INDIANA UTILITY REGULATORY COMMISSION

PETITION OF THE CITY OF EVANSVILLE, )  
INDIANA, FOR AUTHORITY TO ISSUE )  
BONDS, NOTES, OR OTHER OBLIGATIONS, ) CAUSE NO. 45545  
FOR AUTHORITY TO INCREASE ITS RATES )  
AND CHARGES FOR WATER SERVICE, AND )  
FOR APPROVAL OF NEW SCHEDULES OF )  
WATER RATES AND CHARGES. )

PUBLIC'S EXHIBIT NO. 5

TESTIMONY OF SCOTT A. BELL

Figure 10-1 Conceptual Layout of South Plant Dewatering Facility

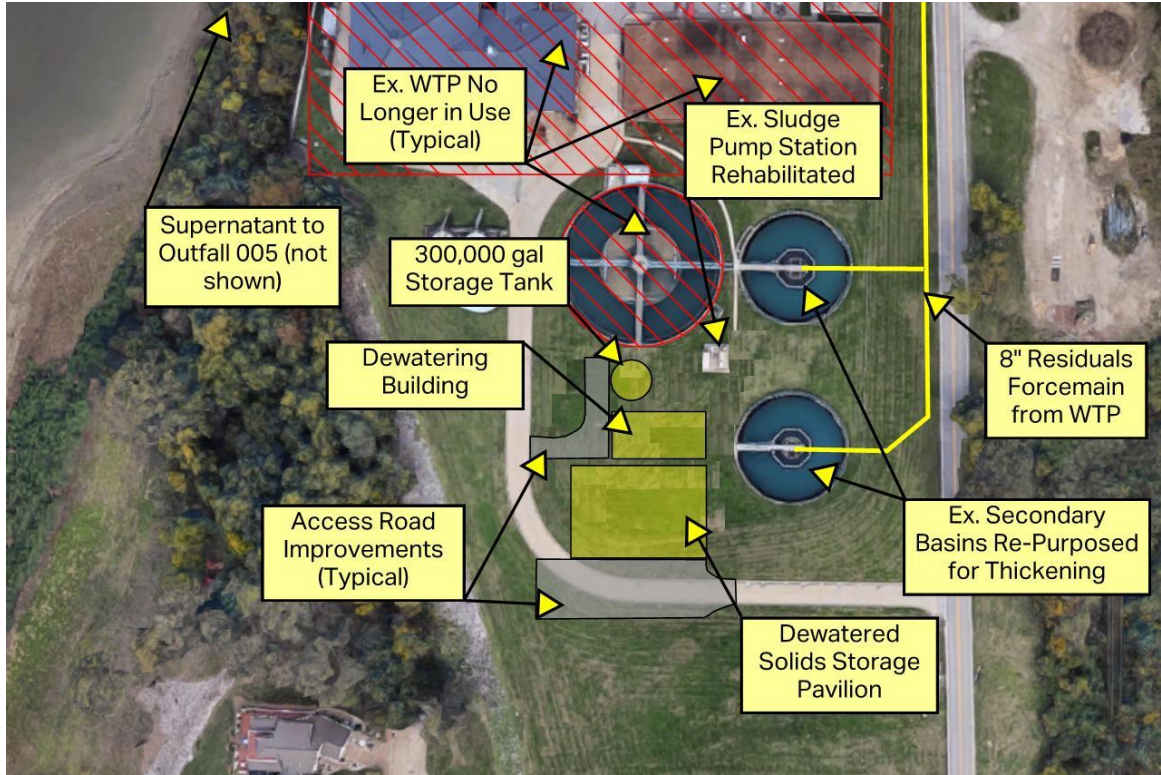
29 **Q: Do you believe it is premature to approve funding (\$30 Million) for a residuals**  
30 **handling facility that may not be necessary?**

31 A: Yes. Evansville has a pending Individual Variance Application for mercury with IDEM,  
32 which if granted may eliminate the need to construct the \$30 million residuals handling  
33 facility. Therefore, I believe it is premature to approve borrowing authority for a residuals  
34 handling facility that will be used to meet discharge standards Evansville is actively

- 19 (1) Deny Evansville's inclusion of \$30 million in its SRF debt financing for Residuals  
20 Management Facility due to the pending Application for a Variance from Indiana  
21 Water Quality Standards for mercury.
- 22 (2) Evansville reevaluate its decision to use a GSC in the construction of the proposed  
23 water treatment plant over other construction delivery methods.
- 24 (3) If Evansville chooses to use a GSC to construct the new water treatment plant, any  
25 unused budget amount should be retained in a restricted account only to be used for  
26 capital projects such as main replacements. Petitioner should also be required to report,  
27 within 60 days of final completion of the water treatment plant project, whether any  
28 unused budget amount remains and how those funds will be used.
